A428 Black Cat to Caxton Gibbet improvements

TR010044

9.105 Applicant's Responses to issues raised at Issue Specific
Hearing 5 on 1 December 2021

Regulation Reference:	8(1)(k)
Planning Inspectorate Scheme Reference	TR010044
Application Document Reference	TR010044/EXAM/9.105
Author	A428 Black Cat to Caxton Gibbet improvements Project Team, National Highways

Wyboston Junction

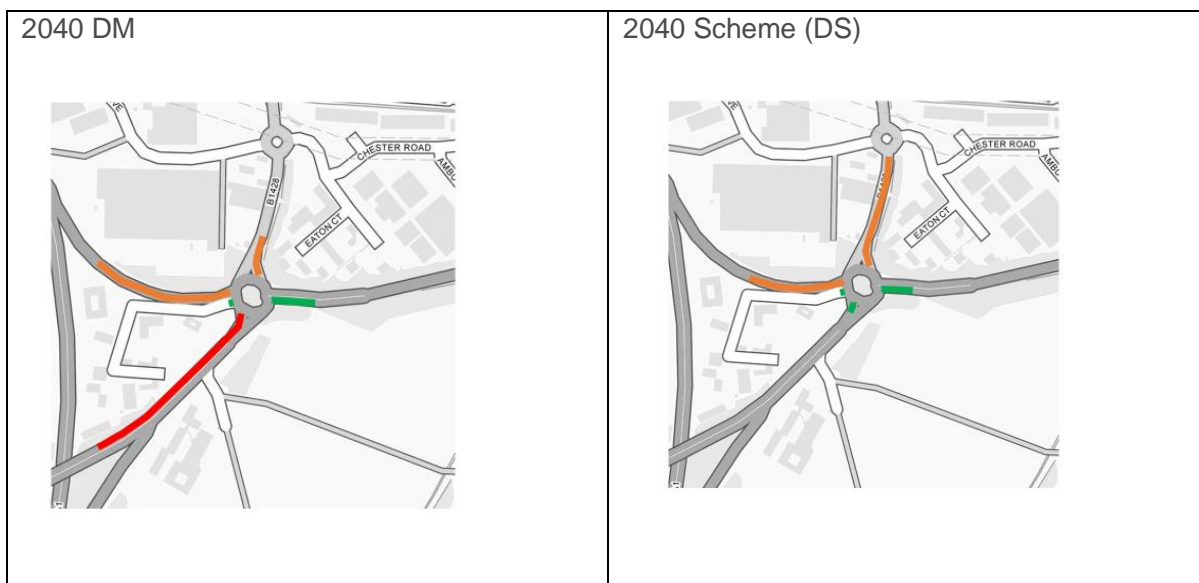
- 6.1.5 In response to this, CCC requested the Applicant to consider the potential to re-allocate road space within the Wyboston and Barford Road junctions to make better use of the underlying capacity of these junctions and to achieve a more balanced outcome for users of the roads concerned.

- 6.1.8 This is a five-arm roundabout, serving the existing A428, A1 southbound off-slip, Great North Road (North) and the access to Phoenix Park (a business park). Great North Road (North) is currently provided as a single lane approach, with a flare to provide two lanes at the roundabout entry. The second lane is approximately 35m long, allowing up to 6 vehicles to queue in each lane, any queueing in excess of this would extend into the single lane section on the approach. The road markings allocate the nearside lane for the use of straight-ahead and left-turning traffic, and the offside lane for straight-ahead and right-turning traffic. The ARCADY model was run in lane simulation mode, with traffic allocated to the lanes consistent with the road markings.

- 6.1.13 The problem identified in the model indicates that more capacity is required to accommodate the left turn from Great North Road (North) towards the current A428 east. In principle, this could be achieved in one of five ways:
- a. Retain the existing layout: re-mark the current lanes to allocate straight ahead traffic to the offside lane only.
 - b. Increase the capacity of the roundabout approach.
 - c. Provide a free-flow left turn lane from GNR(N) into the A428 eastbound exit.
 - d. Reduce the capacity of one of the other arms to provide more gaps in the circulatory flow at the GNR(N) arm.
 - e. Signalisation.

- 6.1.32 After considering the various options of reallocation of the road space on the Wyboston and Barford Road junctions, the Applicant has concluded that by solely adjusting the lane markings, the benefits in traffic operations will be negligible or marginal. More substantive widening or improvements could bring in some potential benefits but they are beyond the scope of the Scheme. Hence, the Applicant does not propose to undertake any further sensitivity tests of any alternative schemes for these junctions, which remain unaltered from their current forms as presented in the DCO application for the Scheme.

Wyboston: 2040 Sensitivity Test: AM Peak

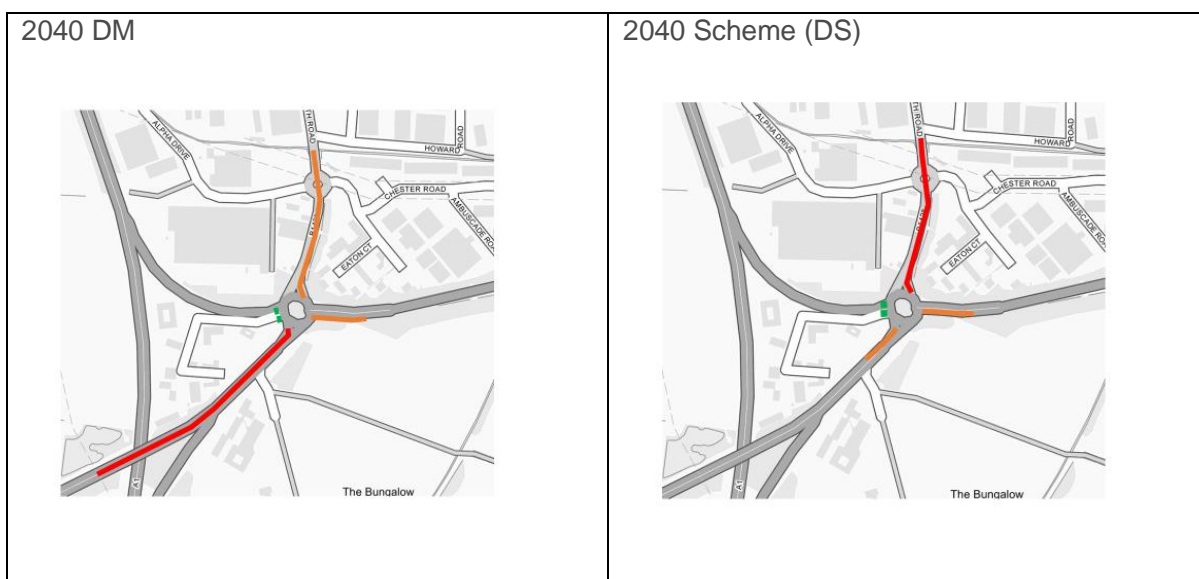
6.1.11 This has been identified as a concern by CCC, who perceive an increased risk of traffic queuing from this junction tailing back to, and affecting the operation of, the local road network junctions on Great North Road to the north of the Wyboston junction, namely the Marlborough Road/Alpha Drive and Howard Road junctions. The sensitivity testing acknowledges that, in 2040, in the PM peak, the queue back from the Wyboston junction could extend through the Marlborough Road/Alpha Drive junction in the "Do Minimum" scenario and, with the Scheme in place, as far as the Howard Road junction. It is important to note however that even without the Scheme these queues are likely to happen in the "Do Minimum" scenario and with the Scheme these queues become marginally longer, especially in the PM peak when the queues are predicted to be at their maximum.

6.1.12 More detailed scrutiny of the ARCADY results reveals that the nearside lane is the busier of the two, carrying about 65% of the traffic and generating the more significant queue. The model indicates that the queue in the offside lane would be contained within the two-lane section.

- 6.1.15 Although the ARCADY model is coded to allow straight ahead traffic to use either lane, the model will already assume that the majority of straight ahead traffic uses the quieter, offside lane. The ARCADY model could be re-run to confirm this by adjusting the lane allocation. However, undertaking a sensitivity test would be of little value because the likely outcome is similar to the main test already reported.

- 6.1.20 For the reasons given at paragraph 6.1.16 above, full-scale signalisation of a roundabout which sees a net reduction in traffic due to the Scheme is not something that the Applicant would undertake as part of the Scheme. However, it might be something for the Local Highway Authority to consider once the Scheme opens and traffic patterns have settled.
